**Reasons For Objections** (no's 1,3 & 4)

Based on the reasons cited under Objections 1, 3 & 4, I feel some confusion may have arisen regarding the previous (2020) and current applications' drainage proposals.

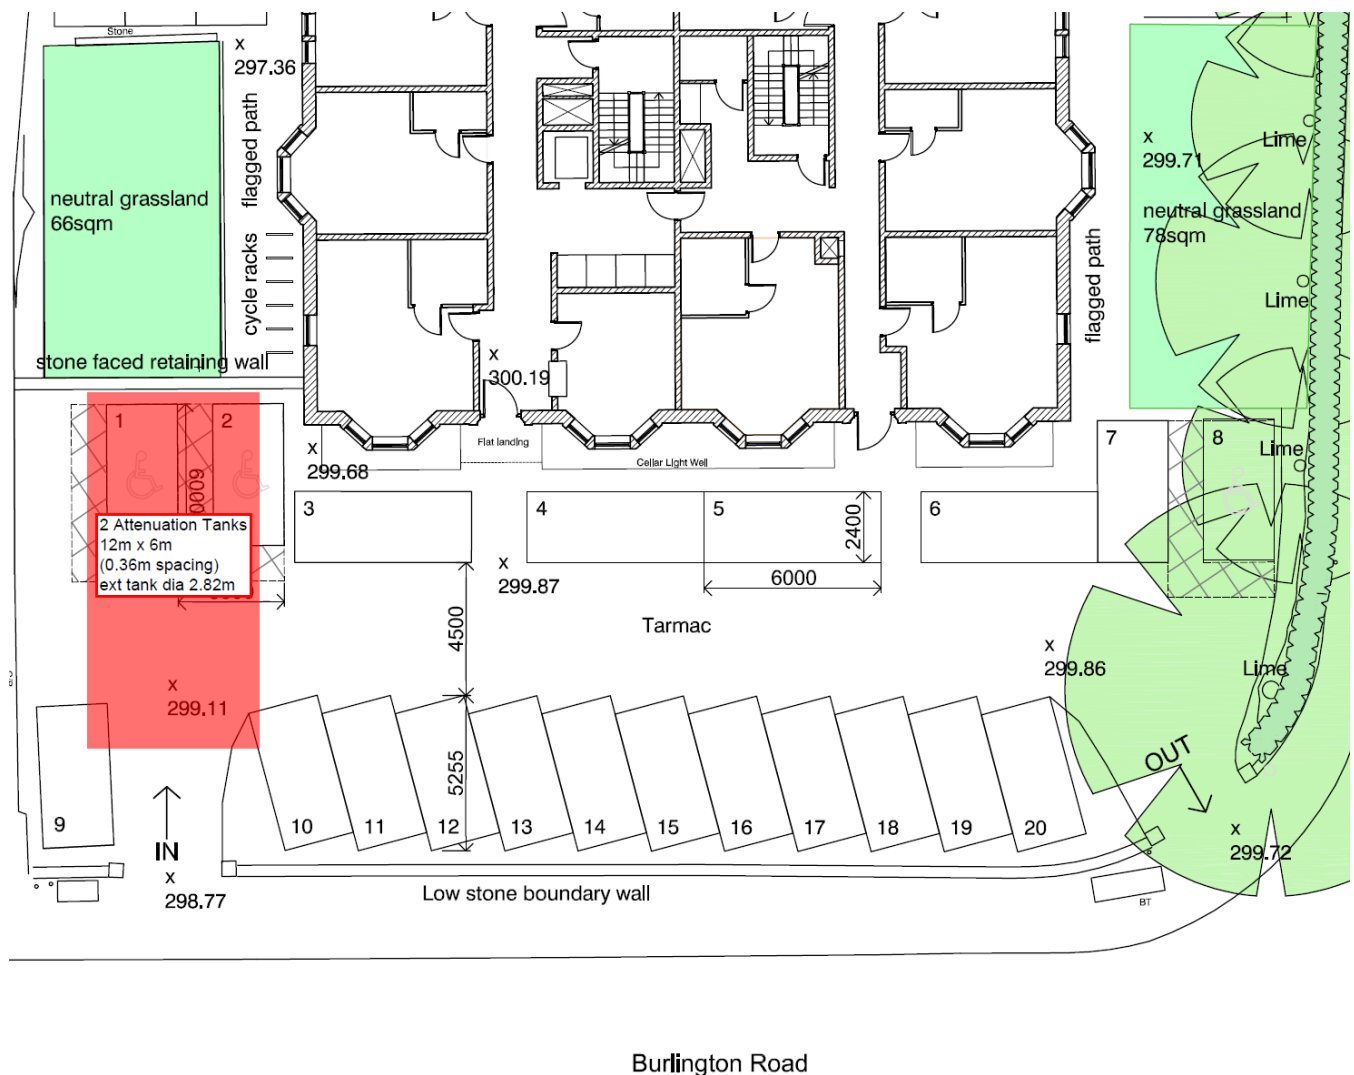
The submitted doc suggested a suitable attenuation option as:

1 x Kingspan Klargest AquaHold SM50- Tank DIA : 2.6m DIA & 10.5m LENGTH Storage Volume: 50,000 Litre

1 x Kingspan Klargest Aqua Hold – SF59 built in flow control 3.5 L/s Tank 2.6 DIA & 12m LENGTH Storage Volume: 59,000 Litre

This is confirmed by the below extract from the submitted *1971.PL03A Proposed Site Plan*, which shows the ground levels of the front car park ranging from 299.86 to 299.11 (with a slope from north to south).

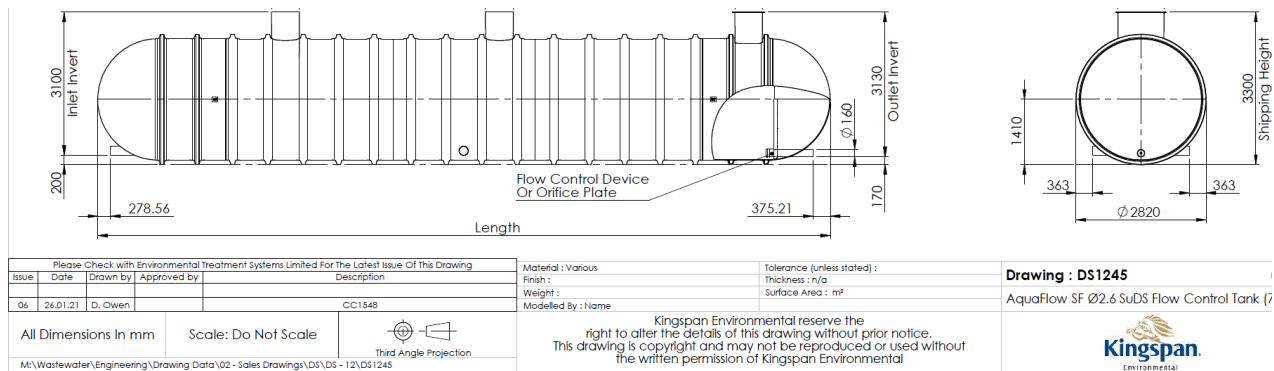
RAB Consultants' *Surface Water Drainage Addendum (May 2019)* advised the invert level of the surface water sewer adjacent to the site to be approximately 295.78m AOD.

RAB Consultants also reported that ground level at the front of the site is typically 299.0m AOD.

A suitable location at 299.11m AOD for the two tanks is shown in red.

The two tanks will be inter connected with the second tank containing a flow control device, allowing the collected water to be discharged to the surface sewer at a prescribed rate.

Based on the Kingspan's published data below, the outlet invert of the tanks is 3.130m, meaning they would discharge at 295.98m AOD (3.13m below the ground level of 299.11).

This is 0.2m higher than RAB Consultants' estimated surface sewer depth of 295.78m AOD and should provide a suitable gradient for discharge, given a maximum estimated distance between the tank outlet invert and adjacent Burlington Road surface water sewer of 7m.
